REMARKS

Applicant has carefully reviewed the Office Action of November 21, 2008, prior to preparing this response. Claims 19-22, 24-26, 28-35, 37, and 38 are pending and have been rejected. With this paper, claims 19, 28, and 37 have been amended. Support for the amendments may be found in the specification, claims and drawings as filed. No new matter has been added. Favorable consideration of the following remarks is respectfully requested.

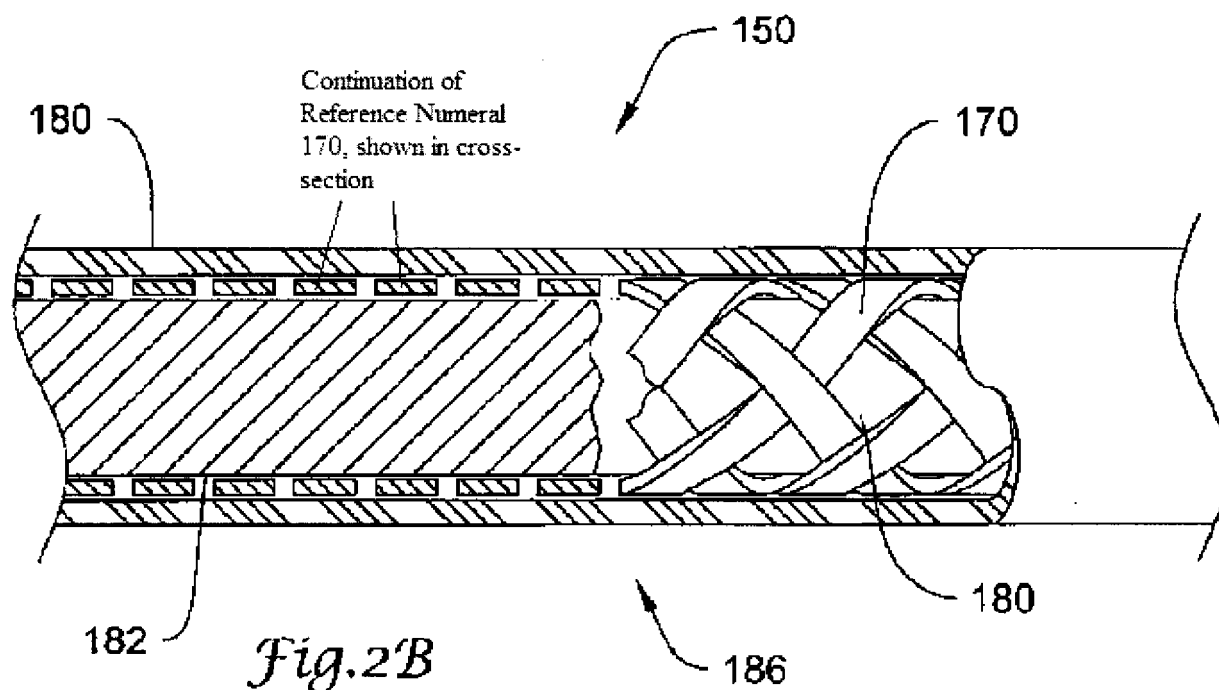
The drawings have been objected to under 37 CFR 1.83(a). The Examiner asserts the overlap between the braid and the tubular shaft must be shown or the feature canceled from the claims. Applicant respectfully asserts the overlap is shown in Figure 2B. In order to facilitate the discussion, Figure 2B has been reproduced below.

As can be seen, the ribbon braid 170 is shown disposed over the tubular shaft 182. One of ordinary skill in the art would recognize that in order for the braid to be disposed over a portion of the tubular shaft 182 and extend distally therefrom, the braid would be disposed over the distal

end of the tubular shaft. Reconsideration and withdrawal of the objection are respectfully requested.
